ARCHITECHNICS, INC.
510 MAINE STREET
QUINCY, ILLINOIS 62301

PROJECT NO. : 5575

ADDENDUM NO.: 1
ISSUED: 2/13/2017

Project: ROOF AND HVAC REPLACEMENT FOR CITY HALL COMPLEX
109 2ND STREET
MONROE CITY, MO 63456

ROOF FRAMING PLAN

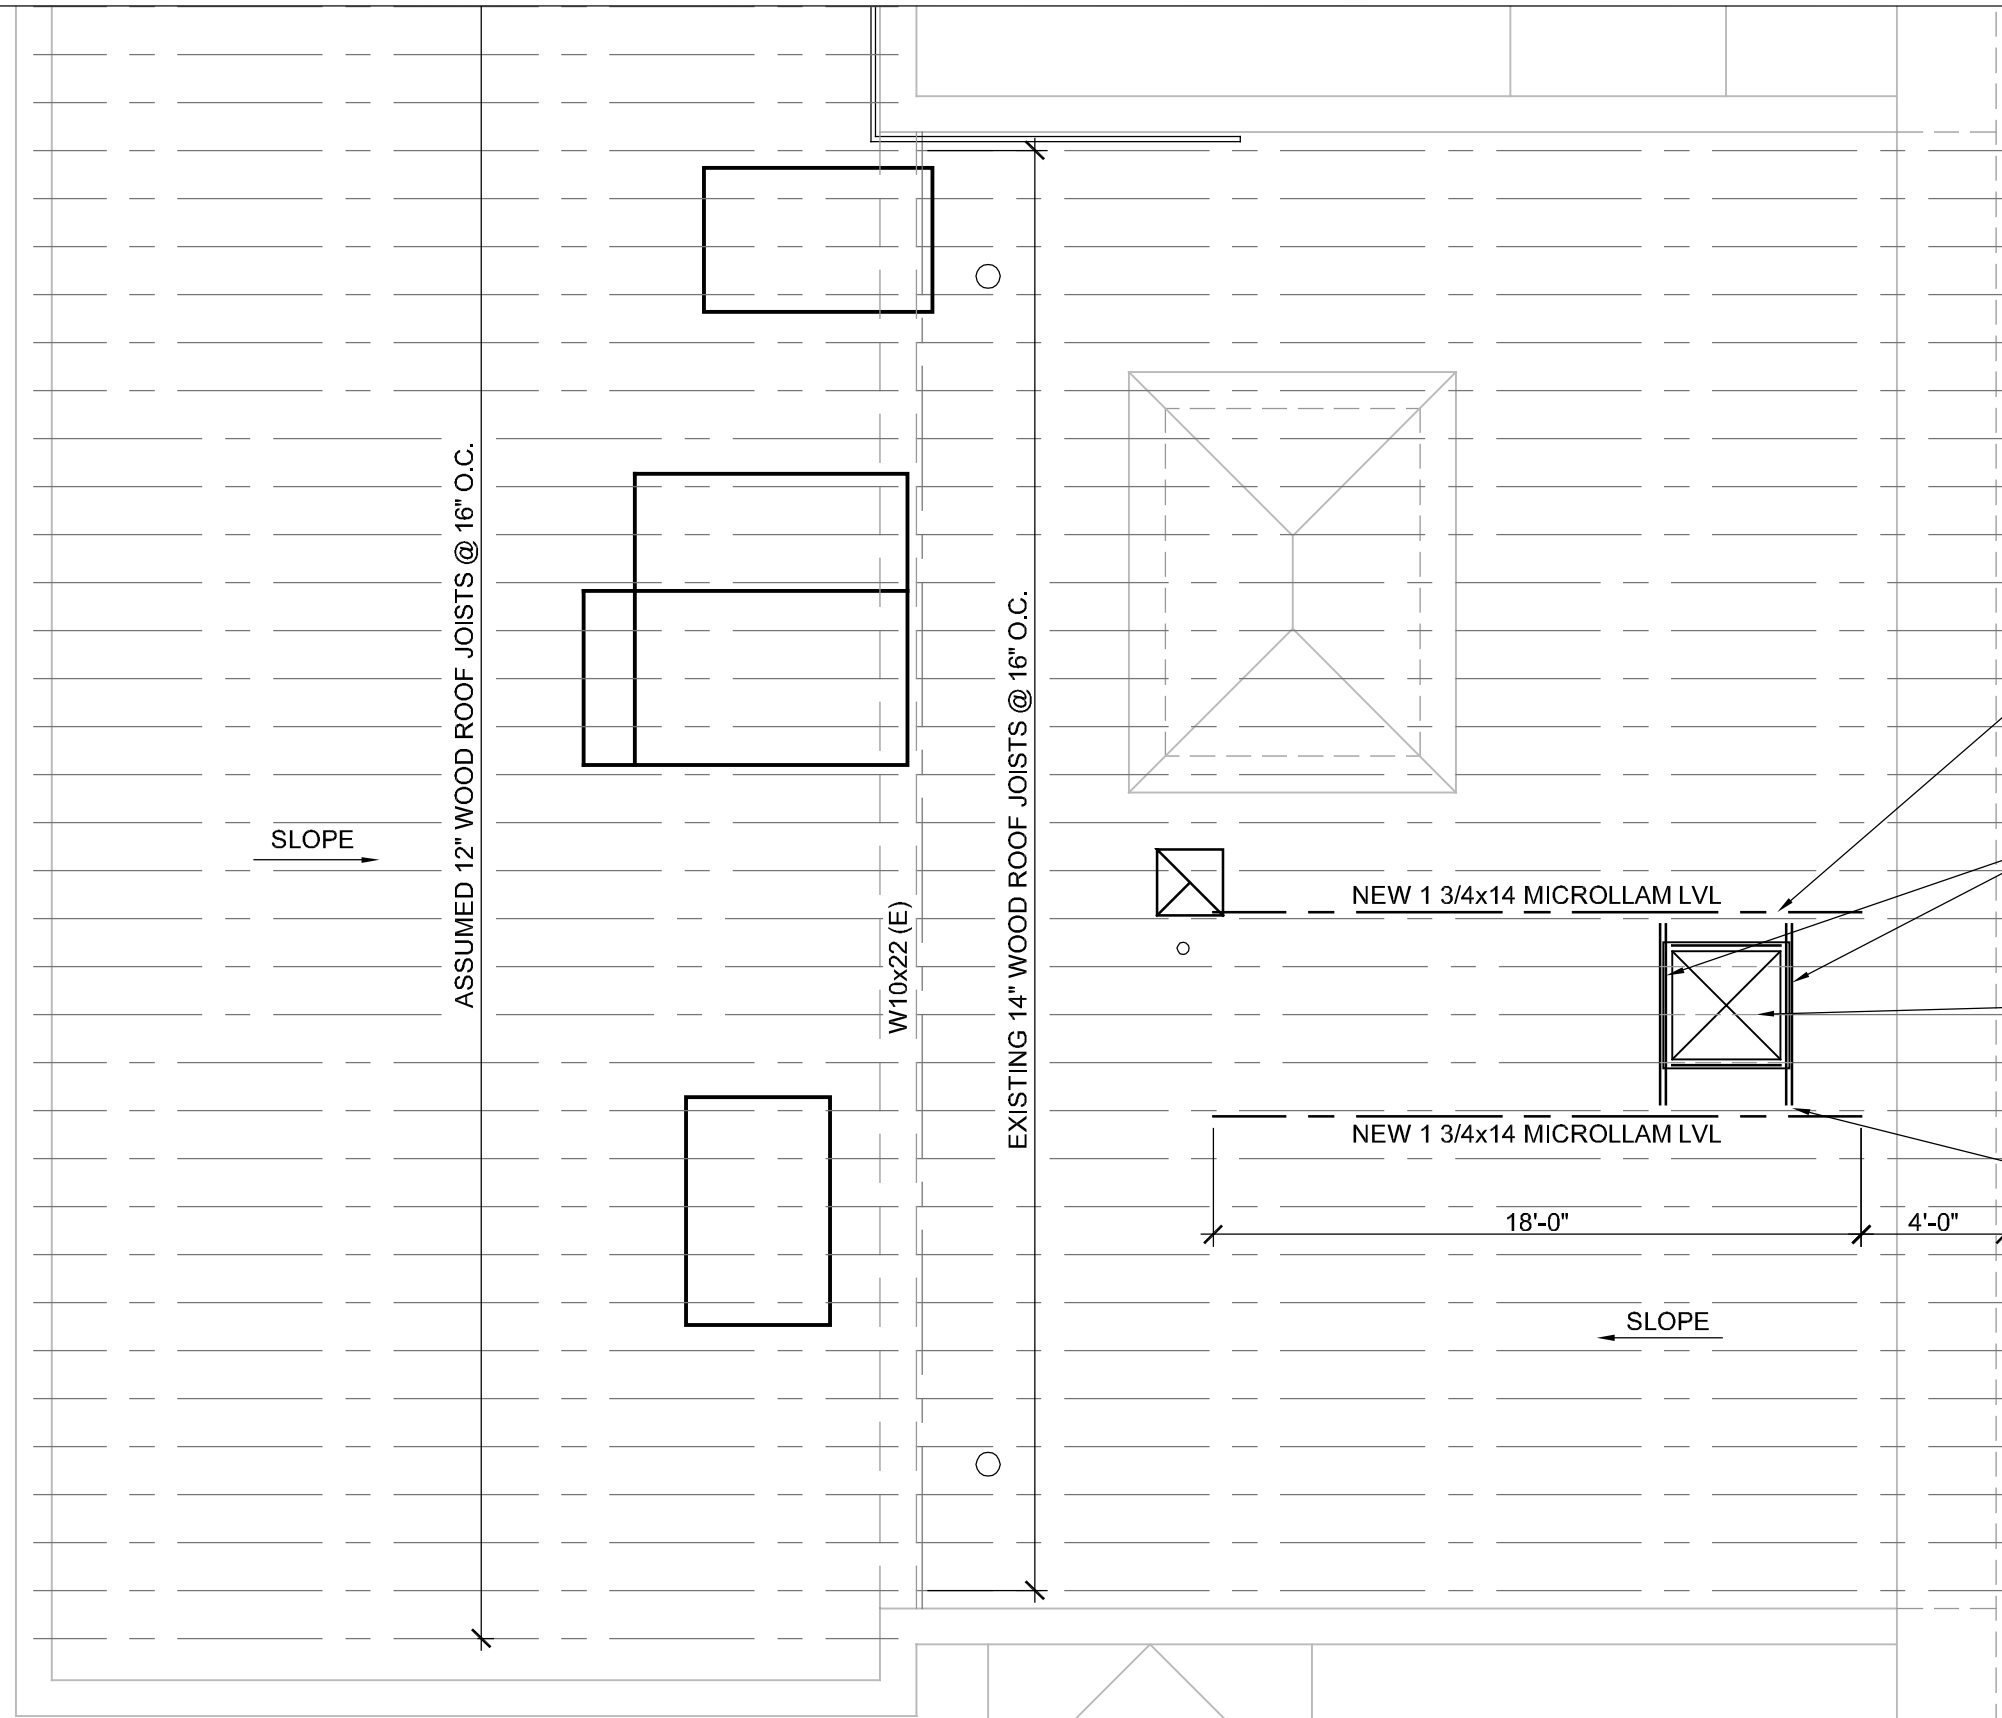
NOTE:
 G.C. TO SHORE EXISTING ROOF
 CONSTRUCTION AS REQUIRED
 UNTIL ALL FRAMING MODIFICATIONS
 AND CONNECTIONS ARE COMPLETE

ANCHOR NEW MICROLLAM
 TO EXISTING JOIST WITH
 1/2"Ø x 3" LONG LAG SCREWS
 T&B AT 6" O.C. (TYP)

NEW (2) 2x12 HEADER EACH SIDE
 OF OPENING, PROVIDE SIMPSON
 JB214A JOIST HANGERS AT
 EXISTING ROOF JOISTS

PORTION OF EXISTING ROOF
 JOISTS TO BE REMOVED TO
 ACCOMMODATE NEW
 OPENING, SEE ARCH. DWGS.

PROVIDE SIMPSON
 WNP212-2 JOIST
 HANGERS AT DOUBLE
 2x12 HEADERS (TYP)
